5DX-82A-S

S E R V I C E N O T E

Agilent 5DX Series 2L, Series 3, and Series 5000 Systems

The E1135A/B/C PDU may not turn off when the EMO switch (emergency stop) is pressed.

Figure 9

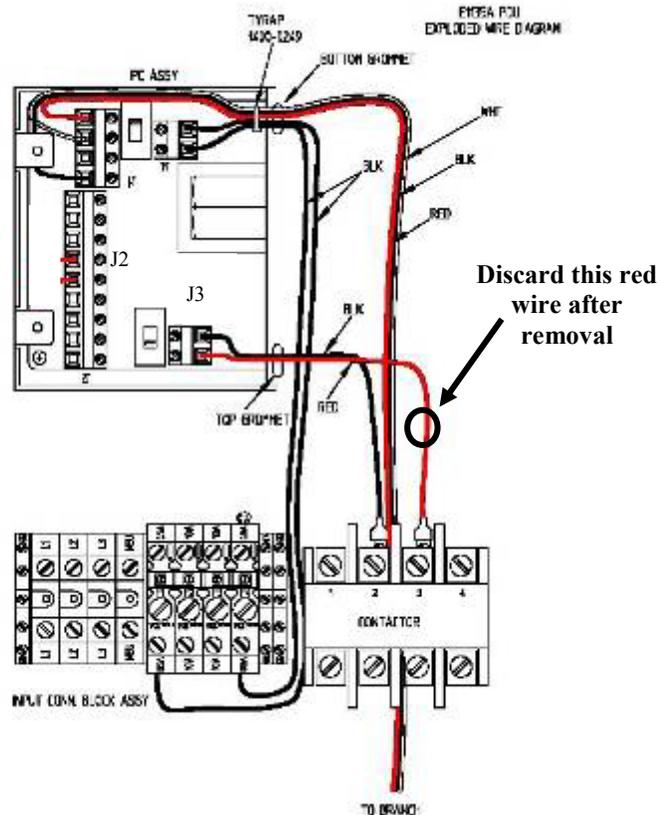
8. Remove the wires from the control board by using a small flat blade screwdriver. (Figure 9)
9. Make note of wire connections to J2 of control board.
10. Discard the red wire that was connected between “Contactor pin 3” and “J3 pin 1 control board”.

Figure 10

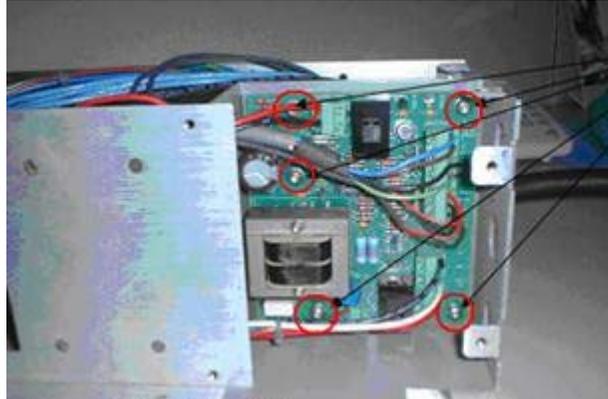
11. Remove the five M4 Torx screws holding the E1135-66501 control board to the PDU using a T20 Torx driver. (Figure 10)

Figure 11

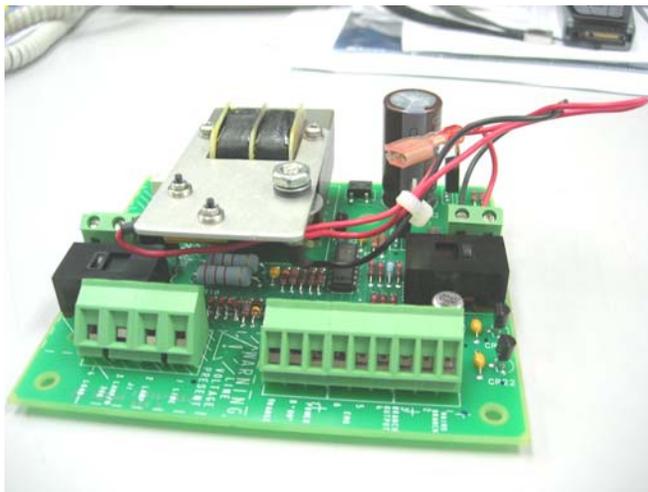
12. Remove the old control board from the PDU and discard.
13. Install the new control board (Figure 11) into the PDU using the five M4 Torx screws removed in step 12. Tighten these screws using a T20 Torx driver and torque to 16 inch-lb (1.81 n-meter)

Figure 12

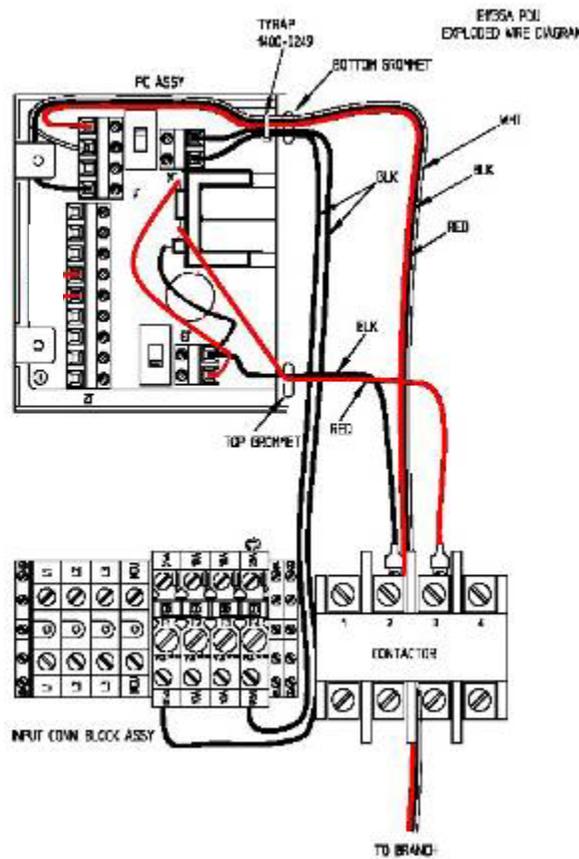
- Re-wire the control board using the wiring diagram in Figure 12 and wires removed from J2 on the control board in step 9.

Control Board to Contactor Connections		
Black Wire Contactor Pin 2	to	Control Board J3 pin 2
Black Wire Control Board J3 pin 2	to	Regulator on Control Board
Red Wire Contactor Pin 3	to	Regulator on Control Board
Red Wire Control Board J3 pin 1	to	Regulator on Control Board

Note: Wires from Regulator to J3 on control board are already connected when received from SPO.
